**NOTICE TO BIDDERS D
HARBOR-UCLA MEDICAL CENTER REPLACEMENT PROGRAM
GENERATOR BUILDING RETROFIT PROJECT COMPONENT
BID NUMBER: BRC0000569
SPECS 7962; C.P. 67961**

April 16, 2025
REQUEST FOR INFORMATION/CLARIFICATIONS
HARBOR-UCLA MEDICAL CENTER REPLACEMENT PROGRAM
GENERATOR BUILDING RETROFIT PROJECT COMPONENT
BID NUMBER: BRC0000569

EXHIBIT 14 - Addendum D

1. Addendum D Narrative: Prepared by RBB Architects dated April 11, 2025

DU1-005

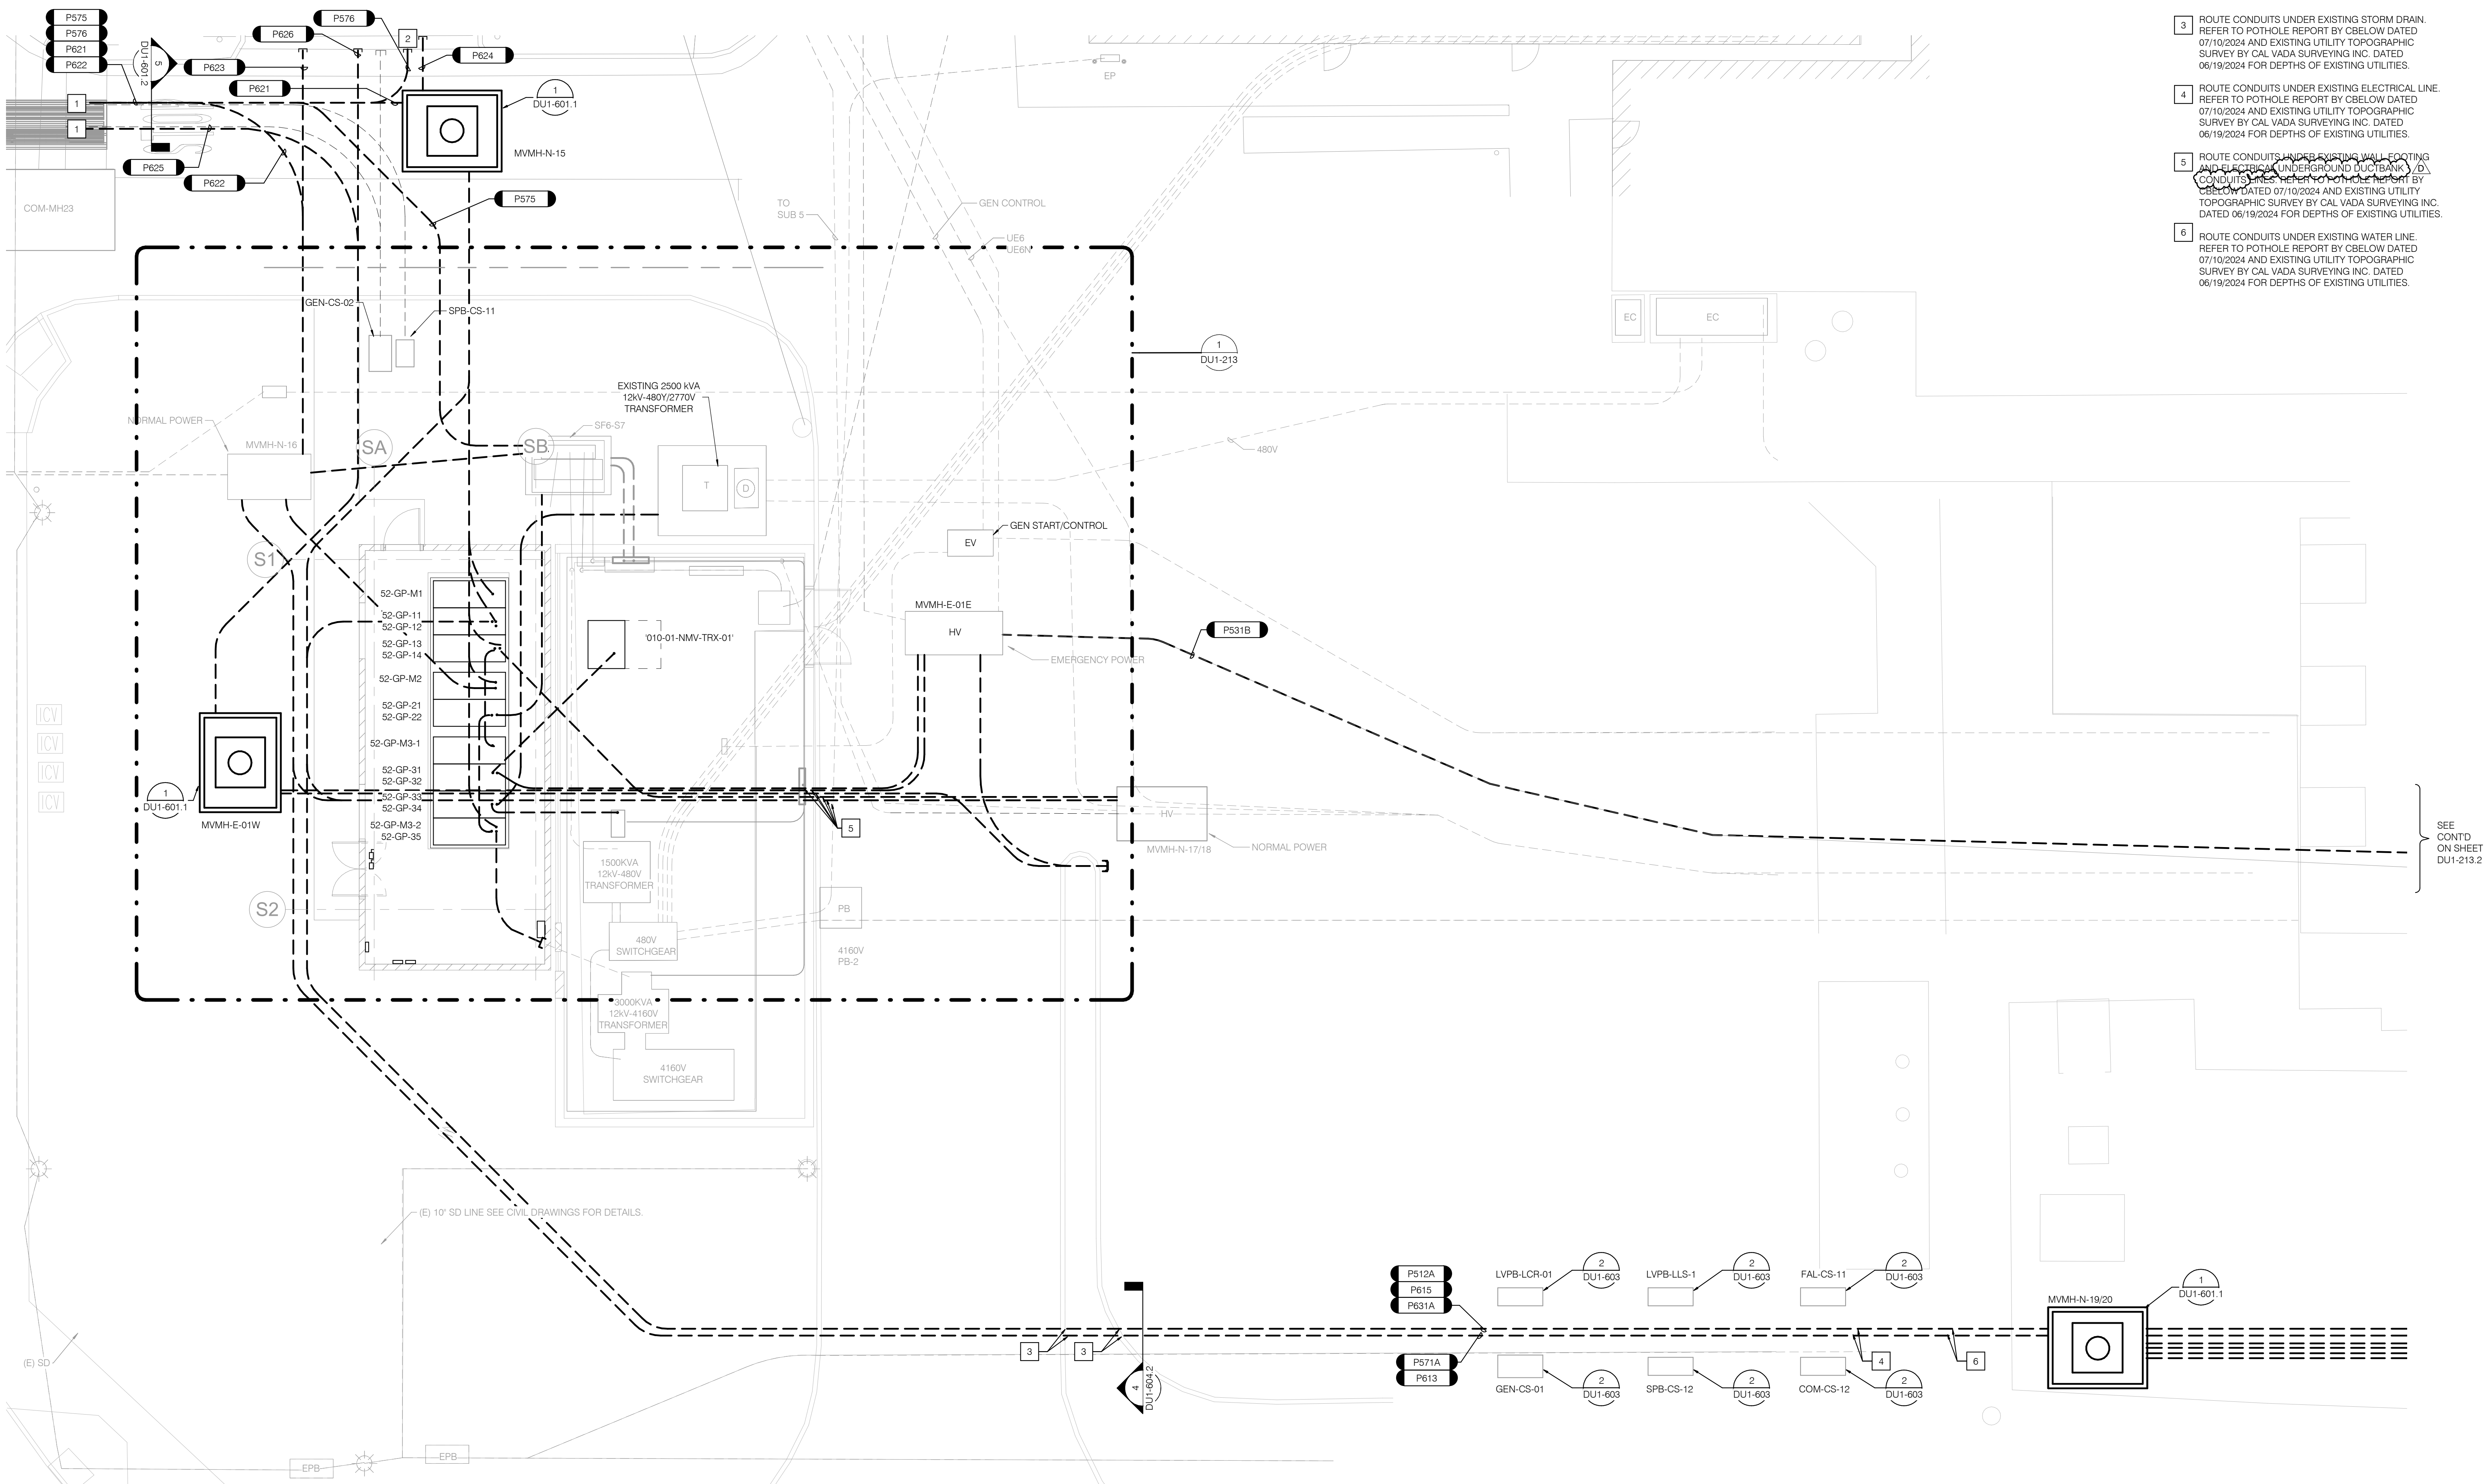
- DU1-004** – Added general notes to provide additional requirements for contractor.
- DU1-005** – Added steps to Sequence of Installation for installation of HVAC and Plumbing equipment.
- DU1-212** – Clarified “Electrical Lines” to “Electrical Underground Ductbank Conduit Lines” on Note 5.
- DU1-221** – Added power cables between switchgear sections and added notes 14 and 15.
- DU1-543** – Removed note 3.

DU1-214.2

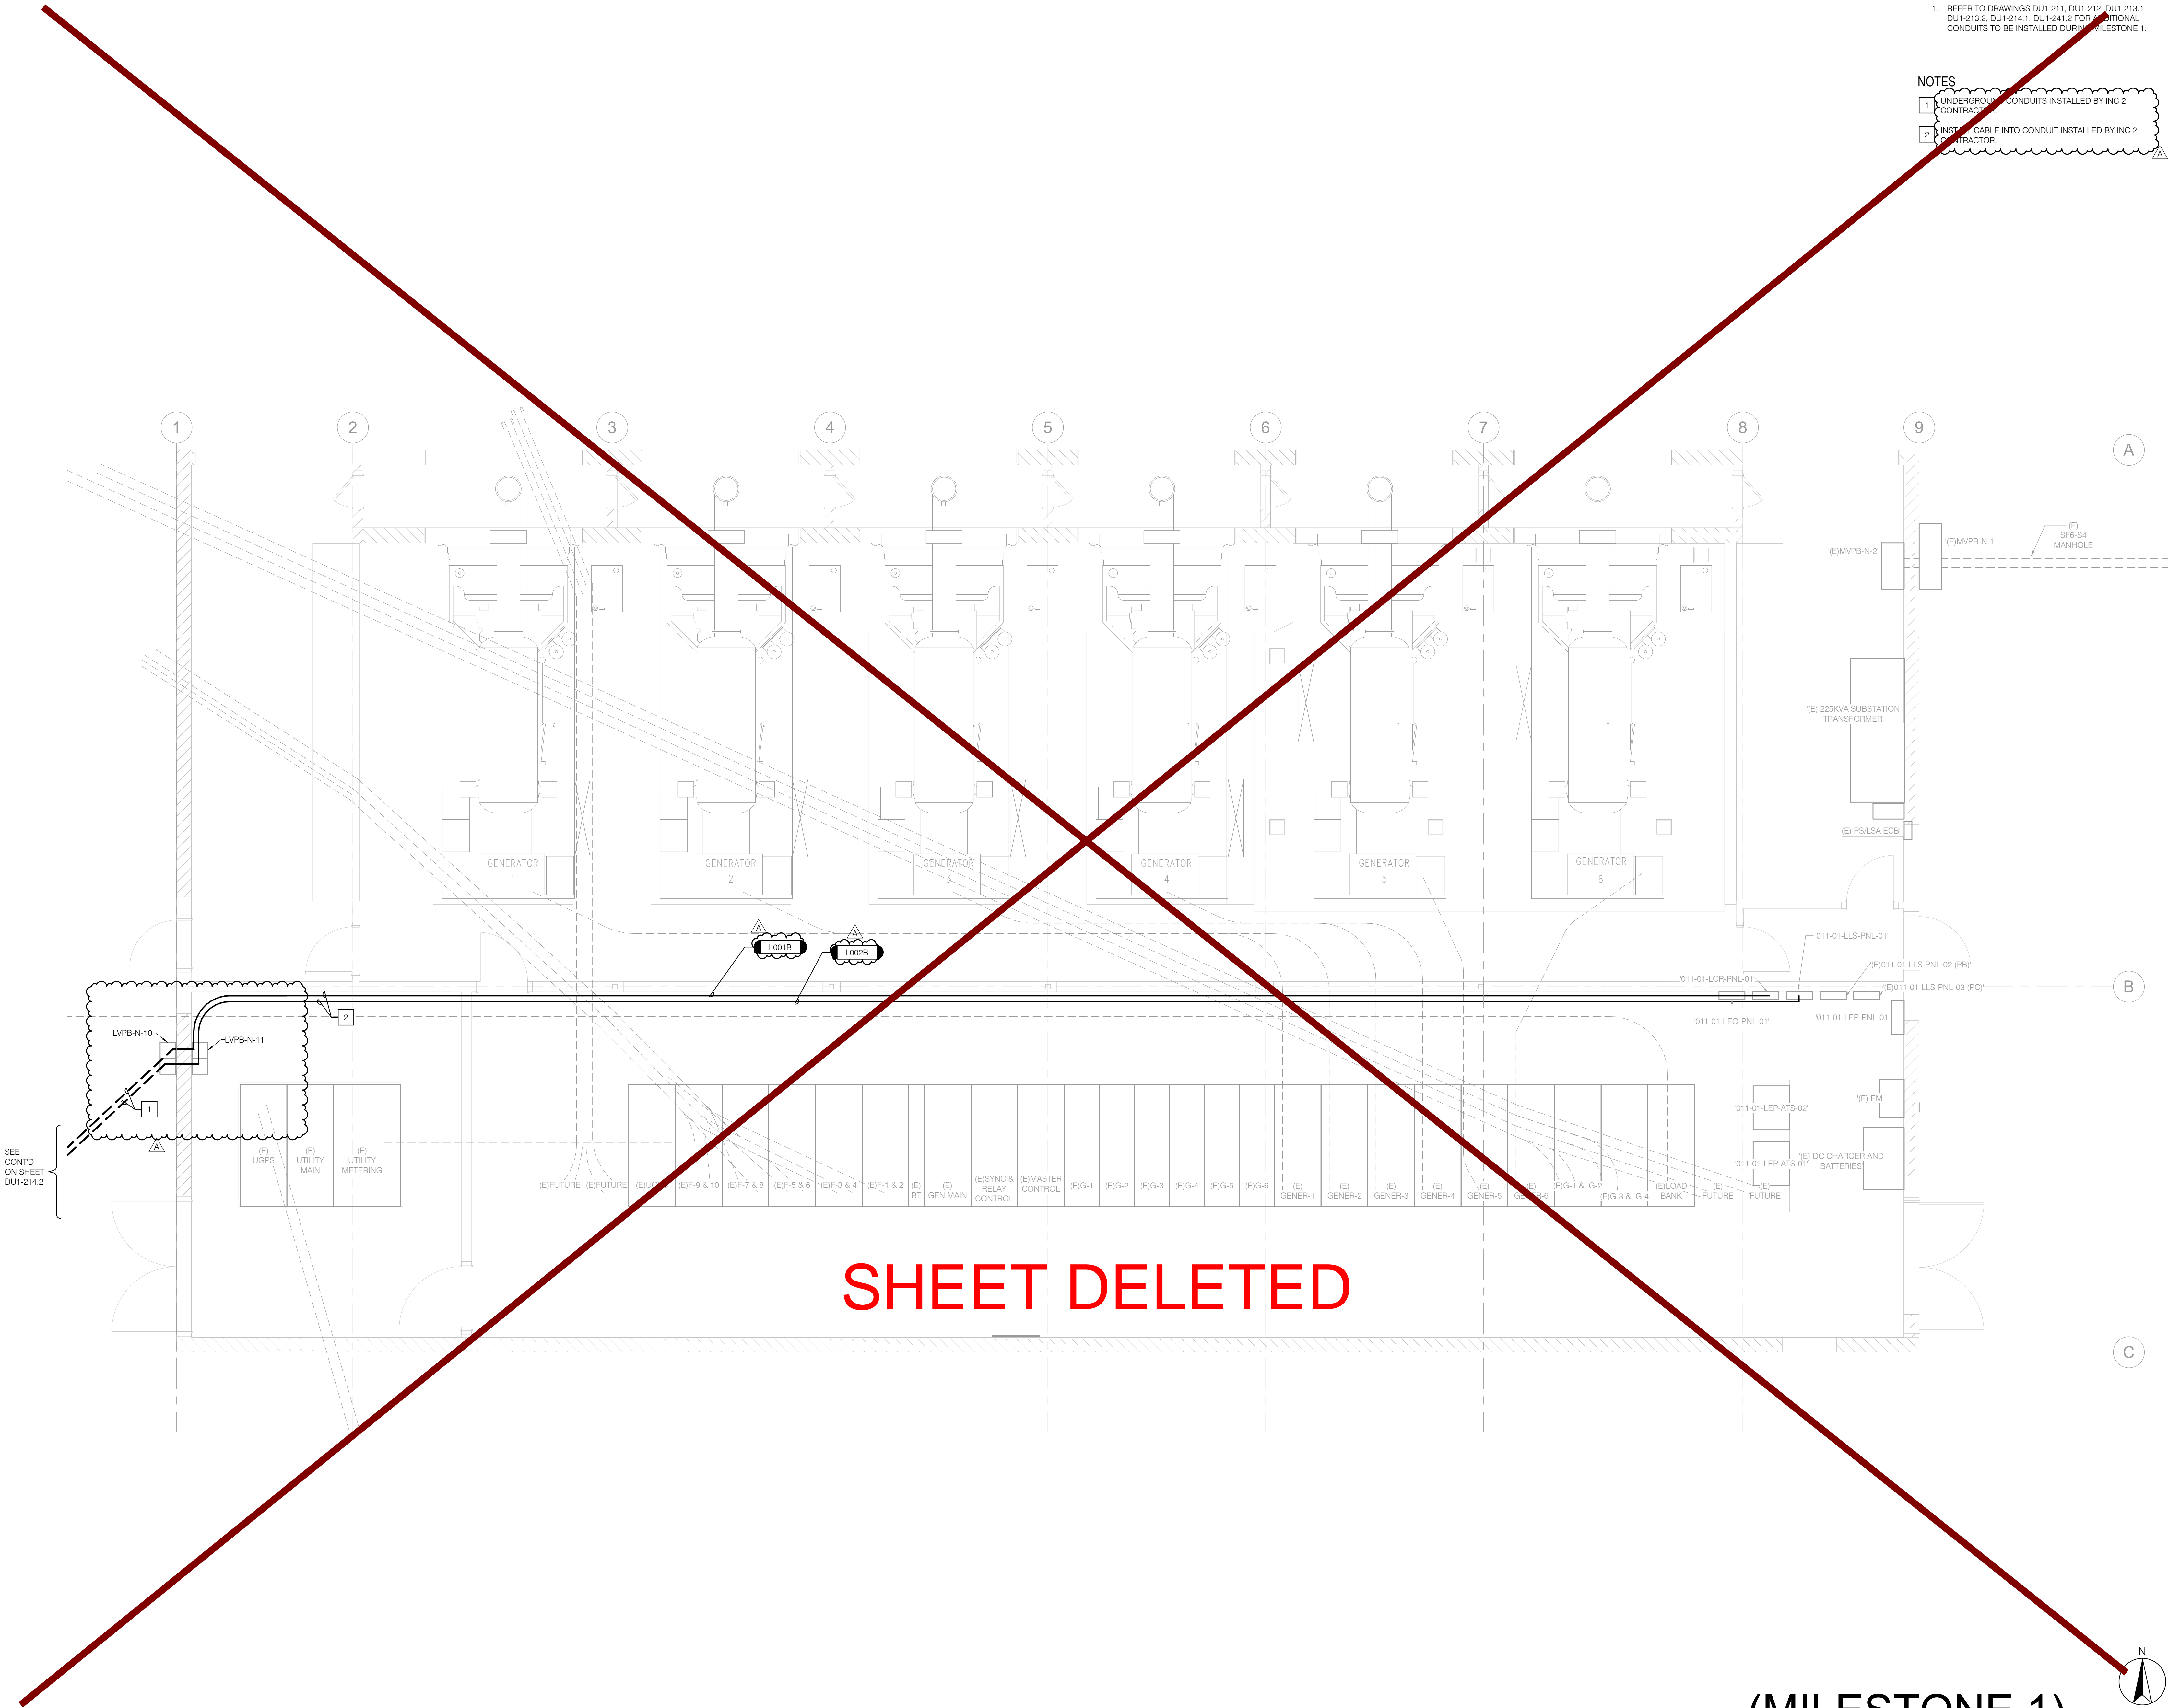
Question Number	Question	Answer	Answer Provided in Notice to Bidders:
14	Reference Inc. #1 Electrical Sheet DU1-214.2 (Bottom Right Corner) Feeder Designations: G002, S001B, C003 & F001. These listed feeder designations are listed on electrical sheet DU1-214.2 and there is a note next to the feeder runs that states: see continued on sheet DU1-214.3. Once on sheet DU1-214.3 there is nothing listed and we need to know where these feeder (conduit's) connect to or what equipment they connect to. Please advise.	G002, S001B, C003, and F001 do not continue on DU1-214.3. See Special Notes 1 and 2 on DU1-214.2 Just to the east of Manhole MVMH-N-19/20 there is a cap shown where these conduits connect to the conduits that are installed by the Inc 2 contractor. See Addendum D.	D
15	Reference Inc. #1 Electrical sheets (conduit and cable schedules). There are feeder designations (P627, P628, P629, P630, P631A, L001B and L002B shown on the conduit and cable schedule but these are not shown on the Inc. #1 drawings. Please provide an electrical site drawing showing these conduit feeder locations, otherwise we will assume that they are N.I.C.	P627, P628, P629 and P630 are NIC and will be removed from the conduit and cable schedule on DU1-403.1, see Addendum D. P631A is shown at the bottom of DU1-212 to the west of manhole MVMH-N-19/20. L001B and L002B can be found on DU1-221 and DU1-224 in Addendum D. DU1-214.3 has been renumbered to DU1-224 in Addendum D.	D
